Notice of Determination

Project Title: Redlands Passenger Rail Project (RPRP)

Following additional coordination with local stakeholders, including the San Bernardino County Flood Control District (Flood Control District) and completion of the Project's 90 percent design, SBCTA is proposing several design refinements to the approved Project. In general, these design refinements are in response to additional hydraulic modeling of the Mission Zanja Channel (MZC) and Santa Ana River (SAR) as part of the approved Project's final design.

Figure 12: MZC Capacity Improvements

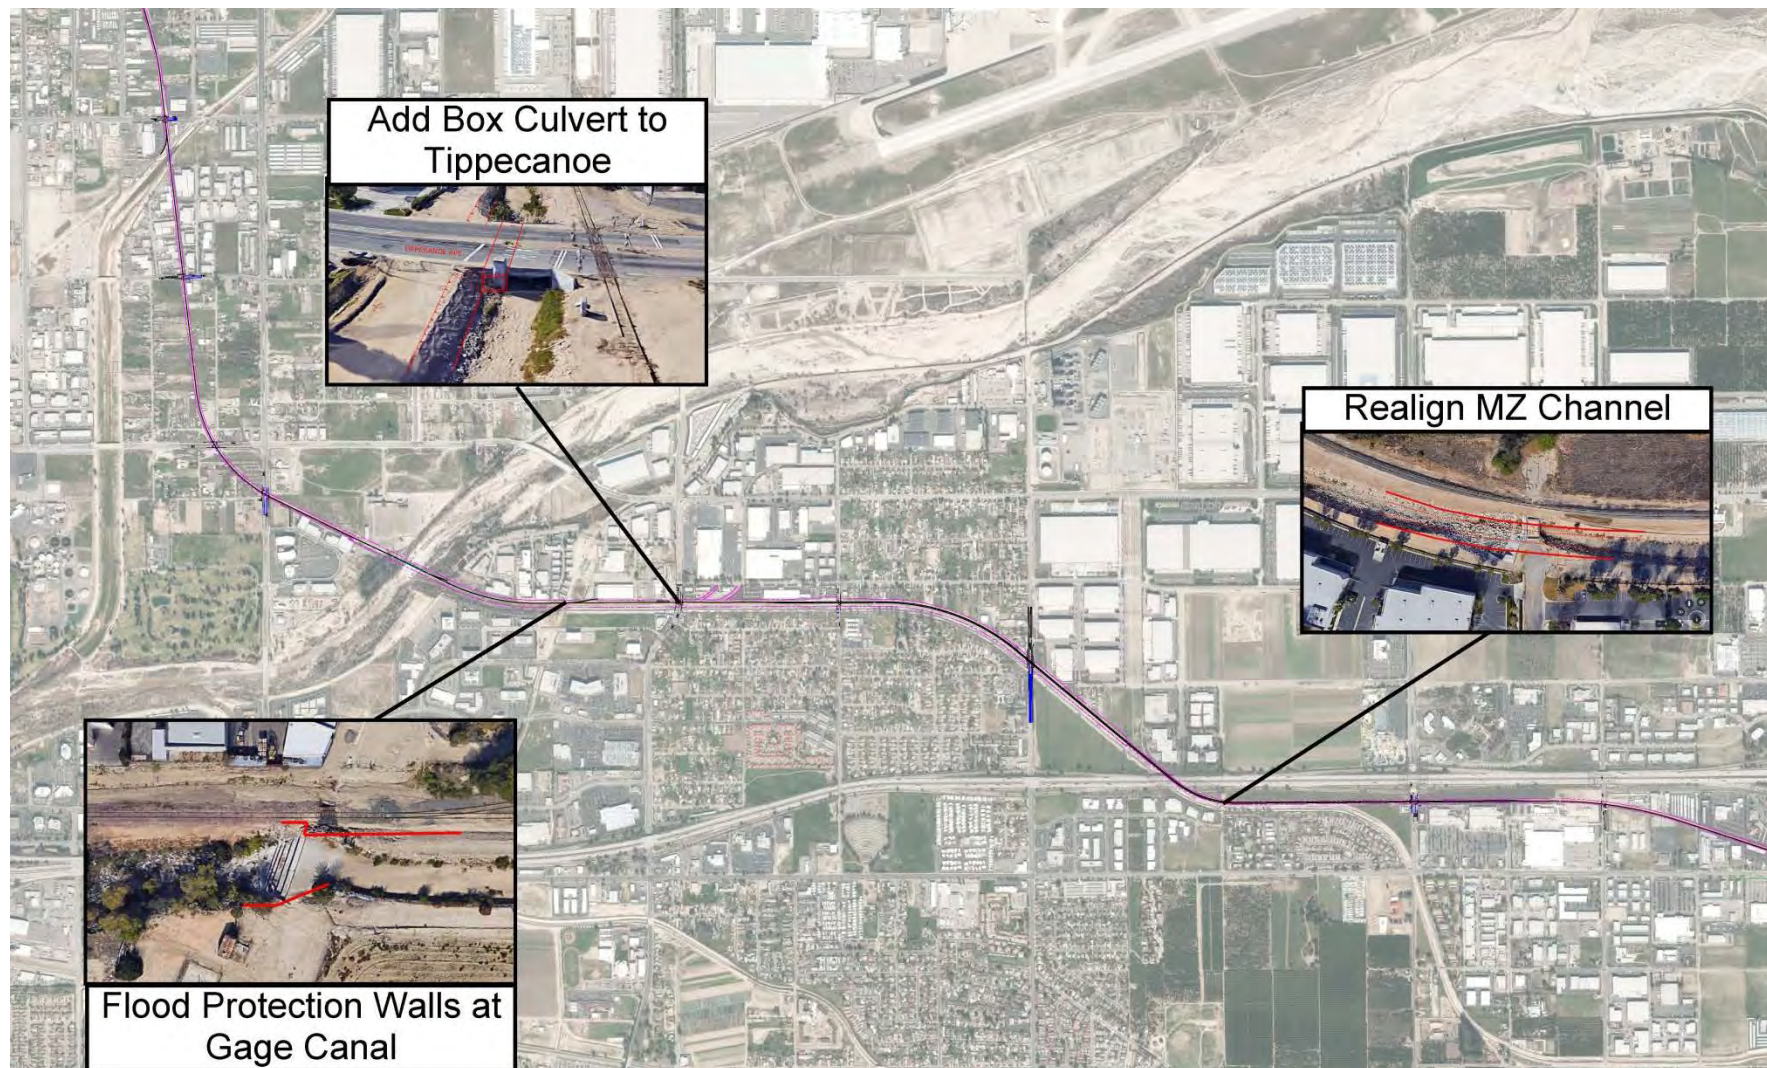
1. *Construct Flood Walls at Gage Canal.* The approved Project included the potential construction of an up to 160-foot, 2 to 3 foot floodwall along the north side of the MZC and within SBCTA's ROW. The refined Project includes this feature along with the construction of an up to 3-foot floodwall along the top of the southern bank of the MZC. The southern floodwall would extend up to 100 feet in length. Figure 12 in Attachment A illustrates the approximate locations of the floodwalls.

3. *Remove Bryn Mawr Bridge (M 5.78) and Realign MZC:* This refinement involves the removal of the concrete bridge structure at the Bryn Mawr Avenue Crossing (MP 5.78). In addition to removing the concrete bridge structure, an up to 600-foot section of the MZC would be realigned and graded to increase the existing channel's capacity (see Figure 12).

Figure 13: Drainage Connection to I-10 ROW at Nevada Street

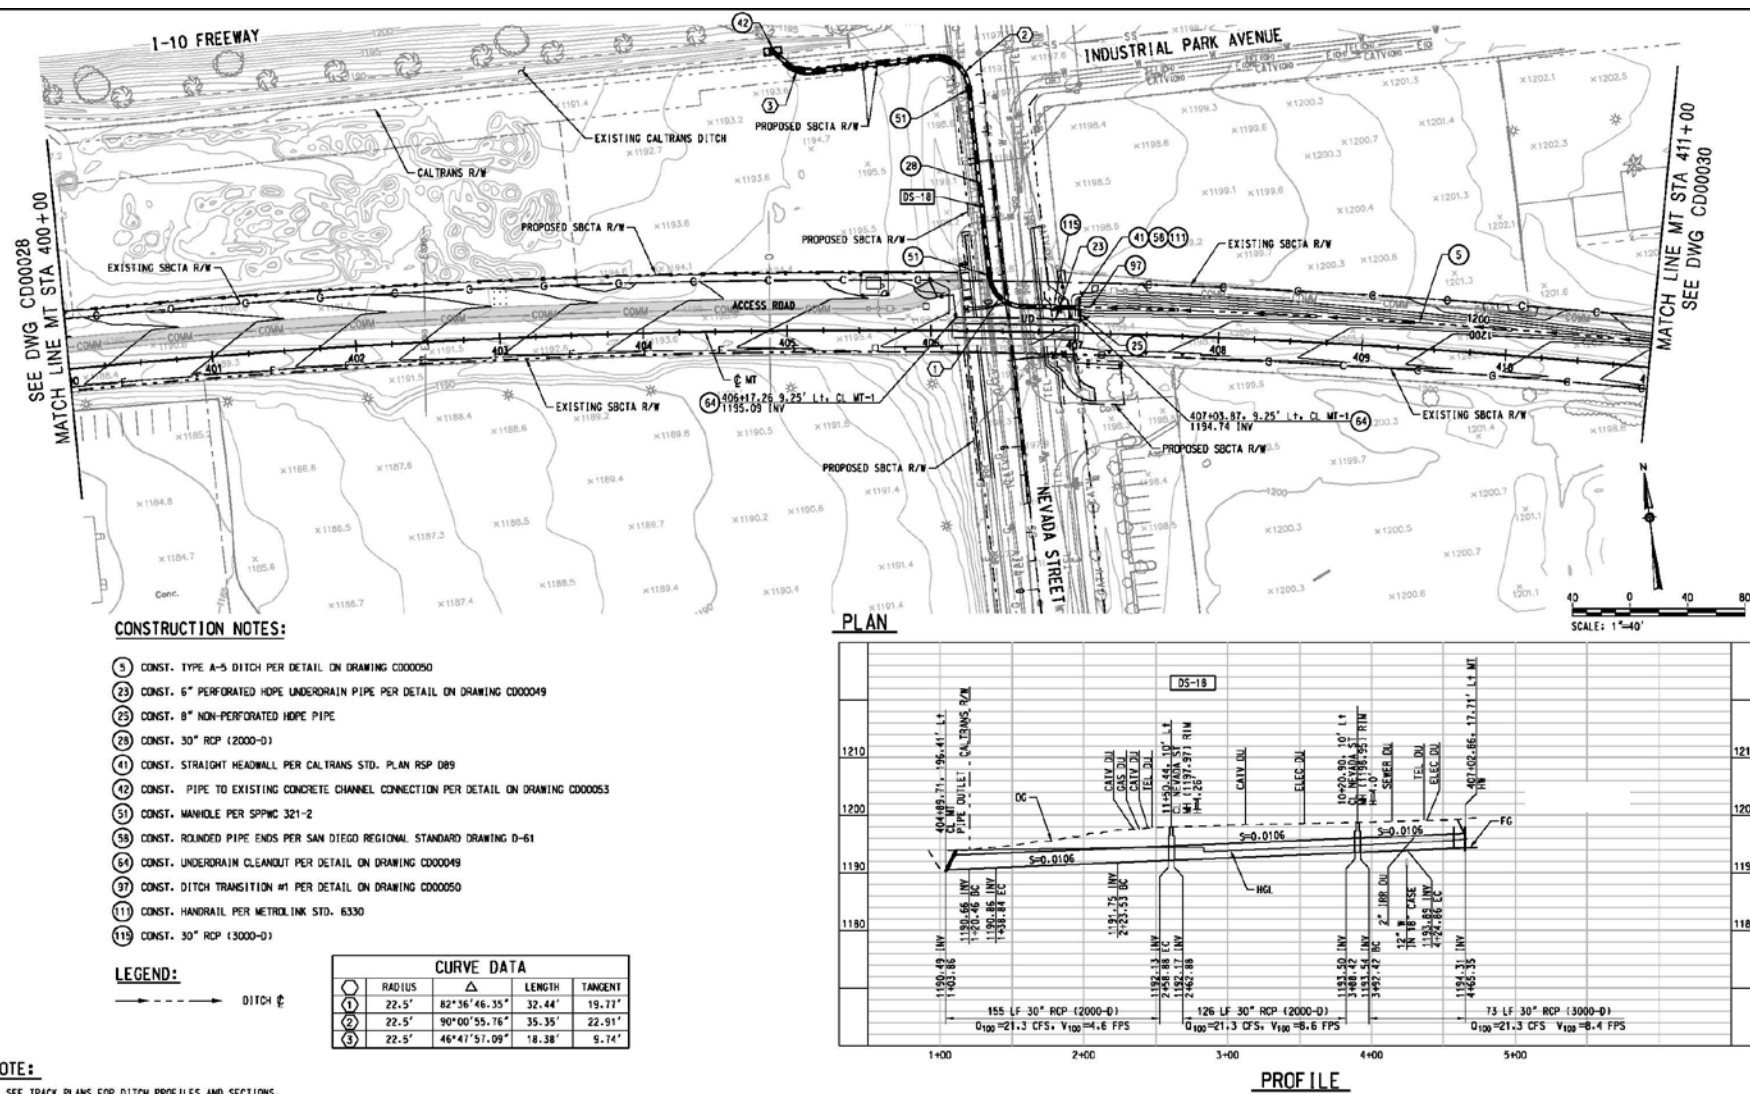
Refinement No. 3 – Caltrans ROW (I-10): In addition to the proposed improvements identified in Refinement No.2, SBCTA is proposing drainage improvements that intersect with the I-10 ROW. SBCTA is proposing a new 30-inch RCP that would extend north from the railroad ROW along Nevada Street to I-10. At I-10, the RCP would outfall into an existing concrete ditch that runs along the southern edge of the I-10 ROW (see Figure 15). These flows would then be conveyed west within Caltrans I-10 ROW via an existing concrete-lined ditch and would enter the MZC via the proposed 4-foot by 8-foot RCB culvert described under Refinement 2B. Figure 13 in Attachment A illustrates the proposed improvement.
